RE: INFORMATION REQUEST RESPONSES FOR N5L8-1849 SHELL CANADA LIMITED, WATER LICENCE APPLICATION – ENVIRONMENTAL SITE ASSESSMENT AT FORMER WELLSITES: IKHIL I-37 AND REINDEER C-36, EAST-CENTRAL MACKENZIE DELTA, INUVIALUIT SETTLEMENT REGION, NORTHWEST TERRITORIES

30 September 2026 Project No. CA0059450.2445

INFORMATION REQUEST RESPONSES FOR N5L8-1849 SHELL CANADA LIMITED, WATER LICENCE APPLICATION – ENVIRONMENTAL SITE ASSESSMENT AT FORMER WELLSITES: IKHIL I-37 AND REINDEER C-36, EAST-CENTRAL MACKENZIE DELTA, INUVIALUIT SETTLEMENT REGION, NORTHWEST TERRITORIES

Figure D: Spill Response Flowchart

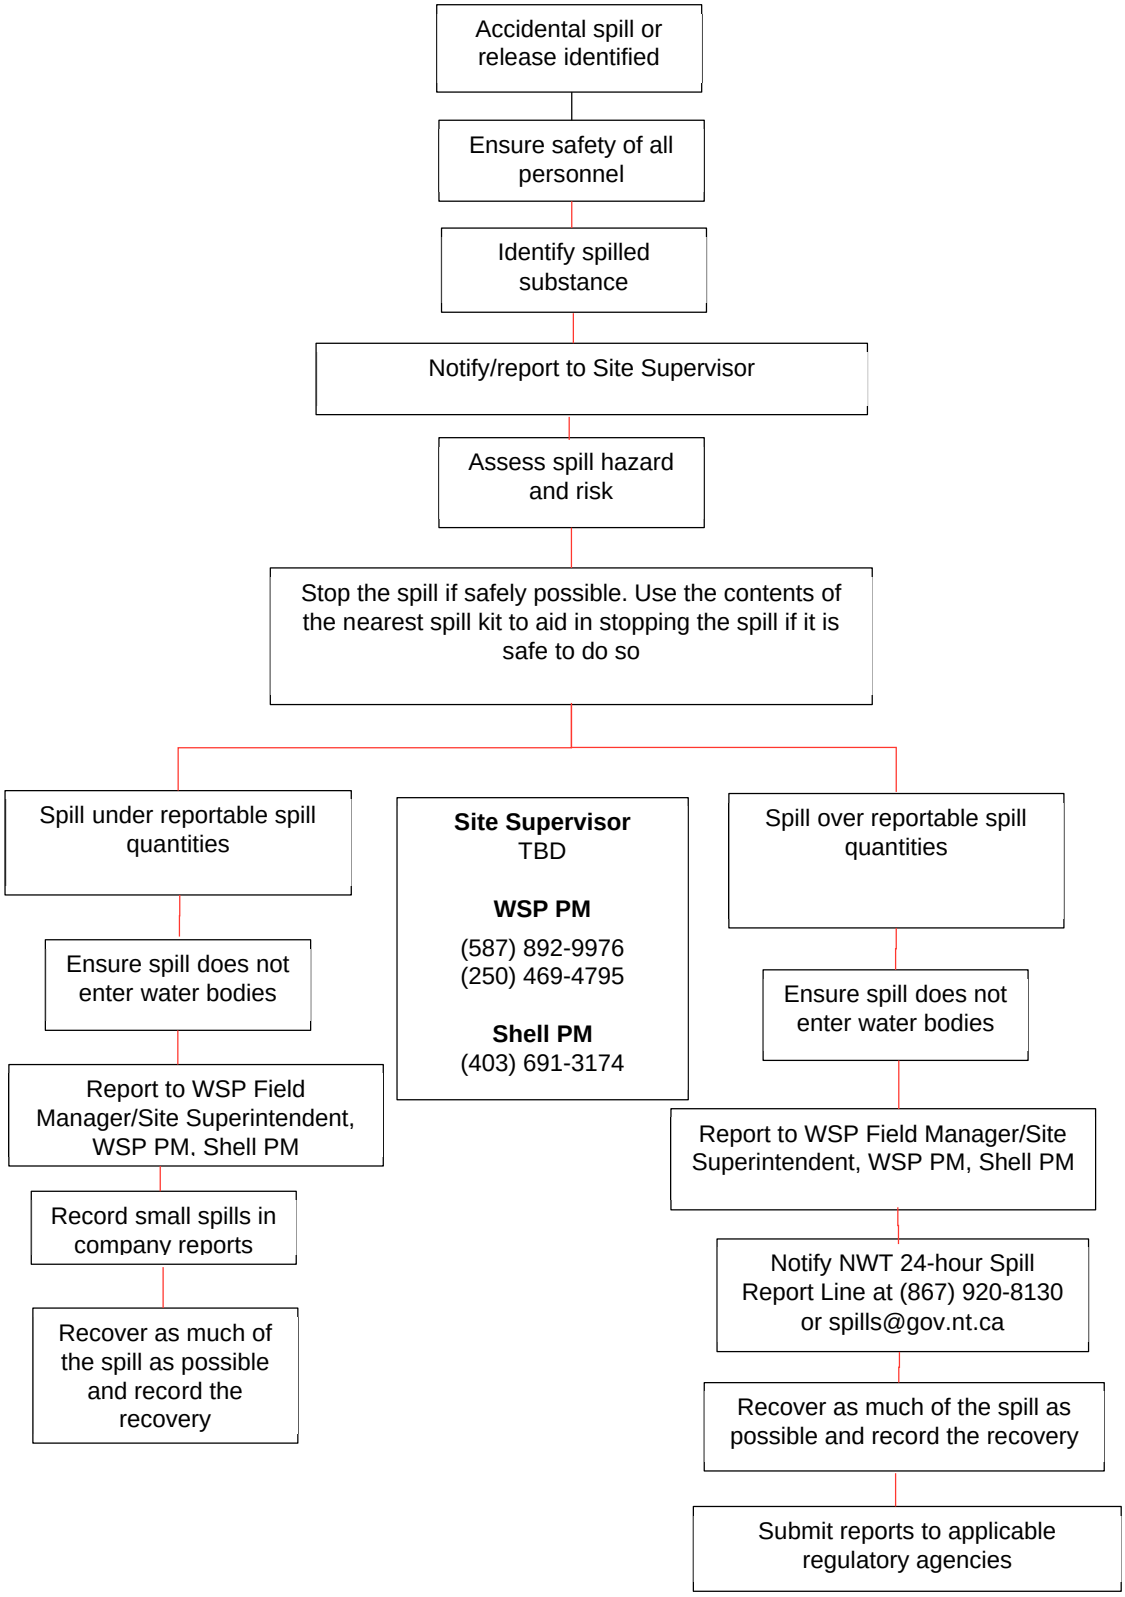
2. **Page 23, Figure D - Spill Response Flowchart: The Spill Response Flowchart presented in Figure D is configured differently from the Spill Response Flowchart presented in the Spill Contingency Plan (SCP), Page 10, Figure A. Please clarify why the Spill Response Flowchart in the Emergency Response Plan (ERP), Page 23, Figure D, differs from the flowchart provided in the Spill Contingency Plan (SCP), Page 10, Figure A. The use of two different Spill Response Flowcharts may cause confusion during the implementation of spill response procedures in the event of a spill. The flowchart presented in the SCP is clearer and easier to understand than the flowchart presented in the ERP. Please consider revising the flowcharts in ERP to ensure consistency between the ERP and SCP and to facilitate clear and effective implementation of spill response procedures.**

Response: To ensure consistency between management plans and to address IR question D.2, Figure D – Spill Response Flowchart in the Emergency Response Plan has been replaced with the clearer and easier to understand flowchart from the Spill Contingency Plan (see below). Please refer to the updated Emergency Response Plan Rev 1, Section 7.6 (Appendix D).

TITLE
IKHIL I-37 AND REINDEER C-36 SITE LOCATION

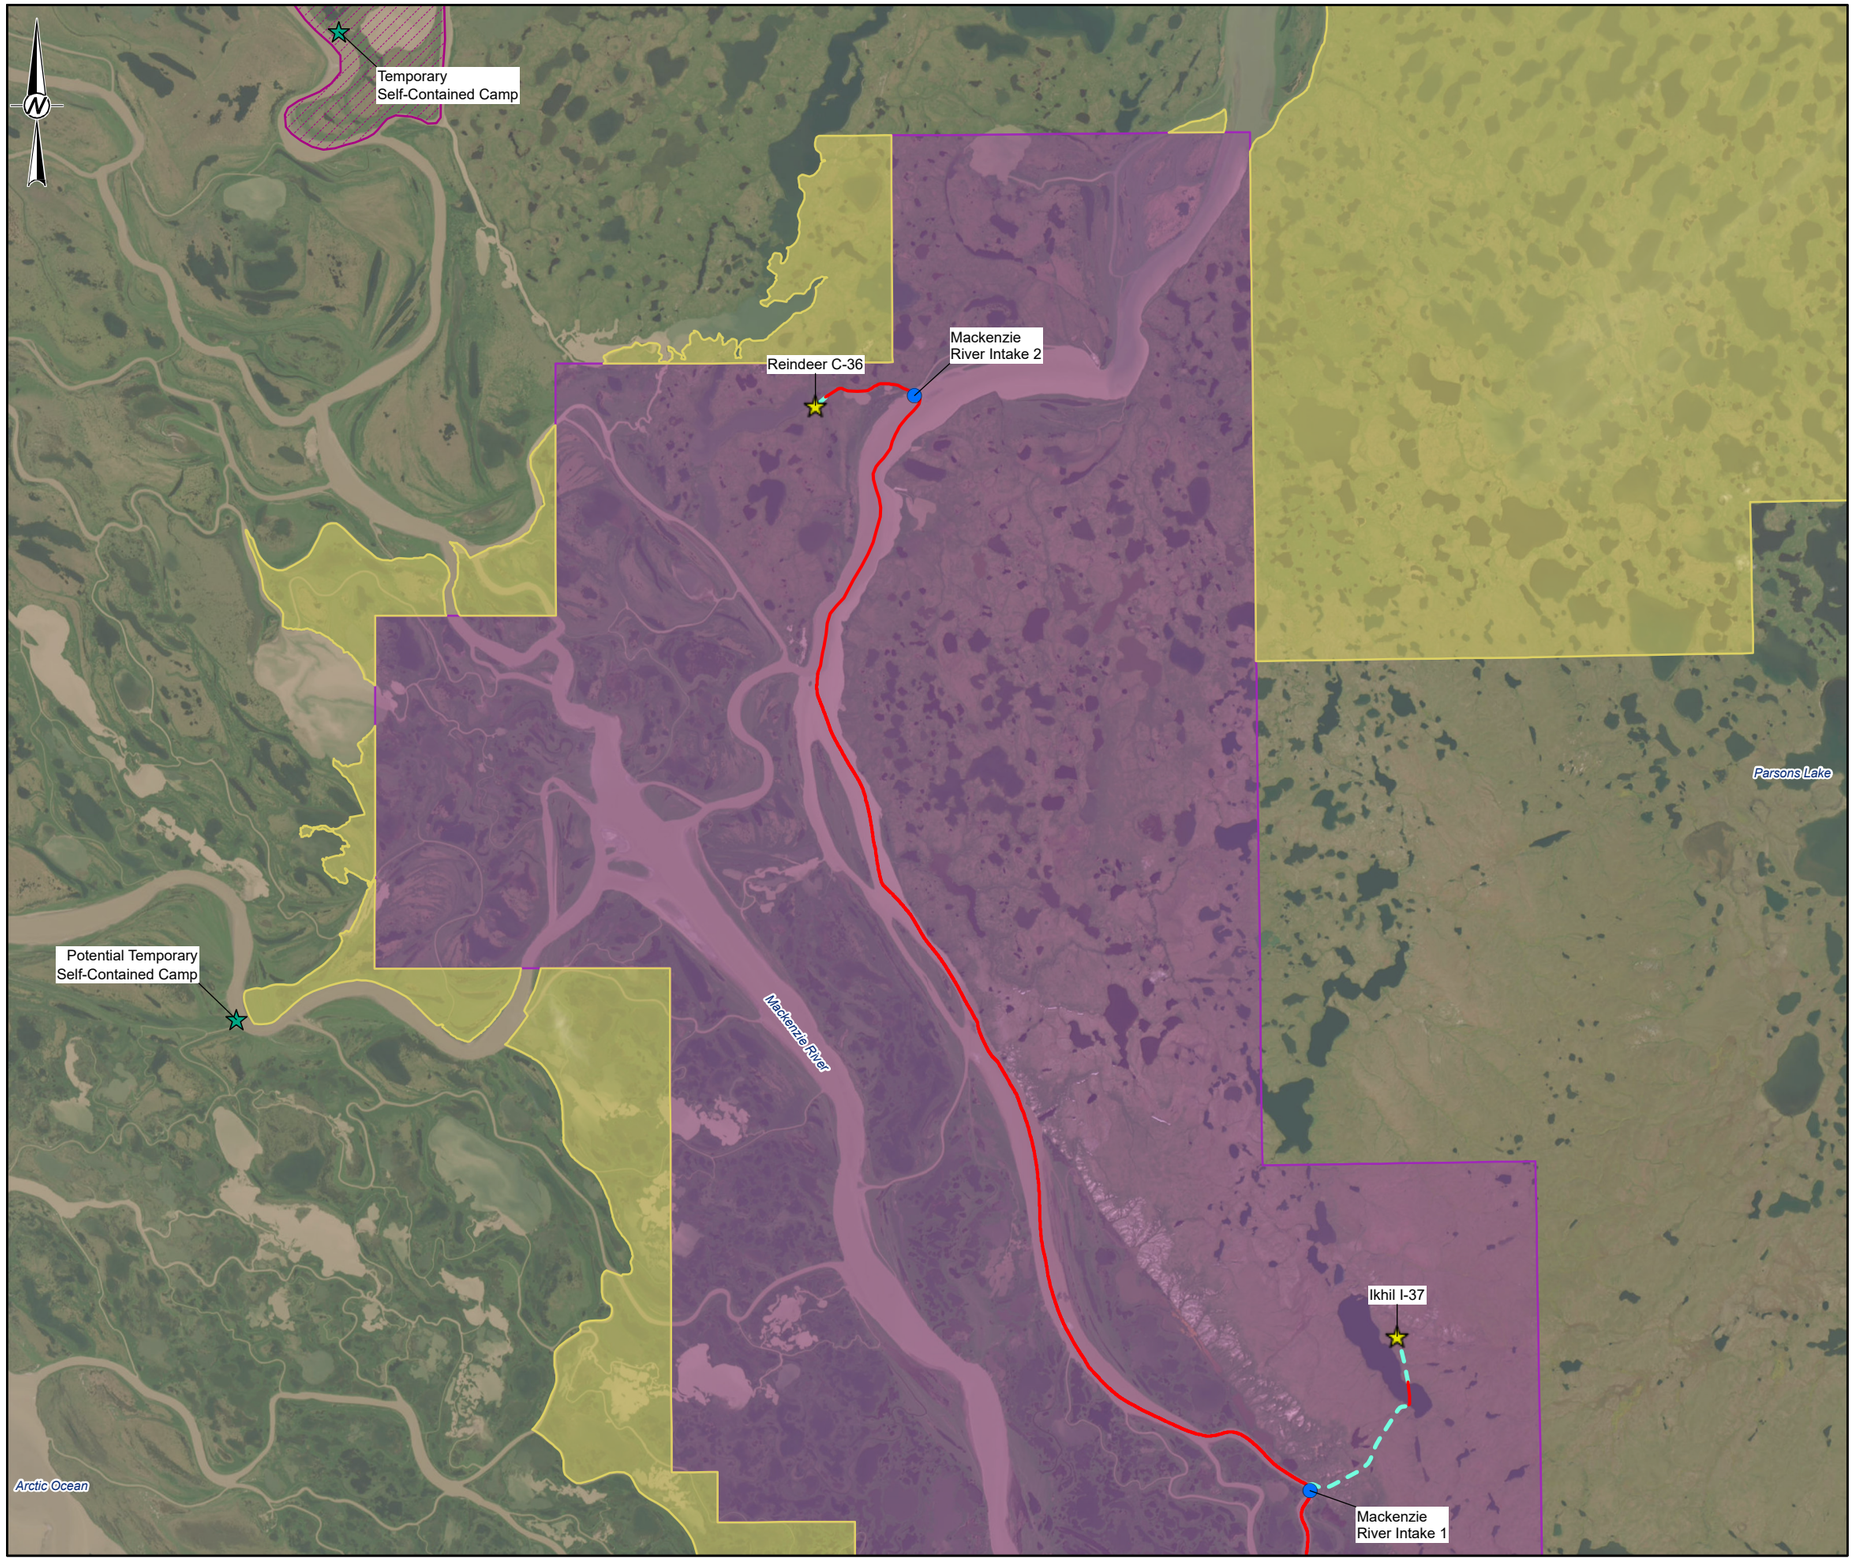
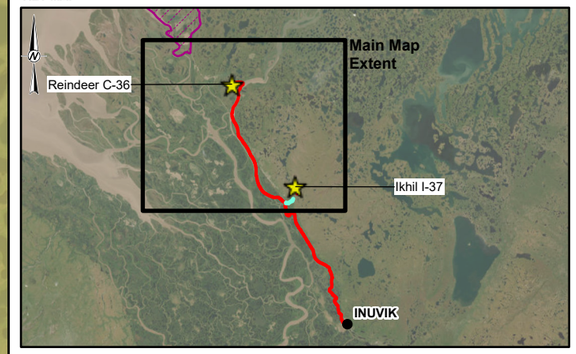
1. **Page 7, Section 5.3.1 states: "No temporary camp will be established at the Sites and accommodations will be provided in Inuvik or at a temporary, self-contained camp permitted and established at Camp Farewell (EISC Registry File: [04/25-06]), or at a temporary, self-contained camp permitted and potentially established on the river ice in the north-central Mackenzie Delta (EISC Registry File: [10/24-04]) for similar work in the ISR". The Water Licence Application submission cover letter and Schedule C, Section 4, indicate that the well sites Ikhil I-37 and Reindeer C-36 are in the east-central Mackenzie Delta. However, the location of the temporary camp potentially to be established on river ice is indicated as being in the north-central Mackenzie Delta. Please clarify this discrepancy. Provide a map indicating location of a temporary, self-contained camp to be established at Camp Farewell and on river ice in the north-central Mackenzie Delta, including Global Positioning System (GPS) coordinates (latitude and longitude) in Degrees, Minutes, Seconds (DMS). Note: Due to potential inconsistencies among individual GPS units, it is recommended to use Google Earth latitude and longitude values as the GPS points.**

2. **Page 21, Section 6.4.2.5, Paragraph 4, Line 11 states: "The construction of the snowpack ramps and temporary overland winter access (including watercourse crossings) will use approximately 200 cubic metres (m^3) of water per day, will at no time exceed 299 m^3 per day and the water requirement will be for a duration of approximately six to eight weeks each winter". The water intake location map is not included in Appendix A. Please provide a map depicting the name and GPS coordinates (latitude and longitude), in DMS, for each intake associated with the water sources from which water is to be withdrawn.**

or at a temporary, self-contained camp permitted and potentially established on the river ice in the north-central Mackenzie Delta (EISC Registry File: [10/24-04]) for similar work in the ISR. The location of the temporary self-contained camp established at Camp Farewell and the potential location of a temporary self-contained camp on the river ice in the north-central Mackenzie Delta are provided in Figure 1 (Appendix A), along with a table of GPS coordinates.

Response: The approximate water intake locations for water that will be used to construct the snowpack ramps and temporary overland winter access are provided in Figure 1 (Appendix A) along with a table of GPS coordinates.

Water from the Mackenzie River Intake 1 and Intake 2 will be used for construction and maintenance of the snowpack ramps and overland portions of the temporary winter accesses.

In addition, water pumping locations along the Mackenzie River and from watercourse crossing for the purposes of ice road construction and maintenance (flooding) are not shown on Figure 1. This water will only be used for ice road construction and maintenance on the Mackenzie River and watercourse crossings and not for overland portion of the temporary access.
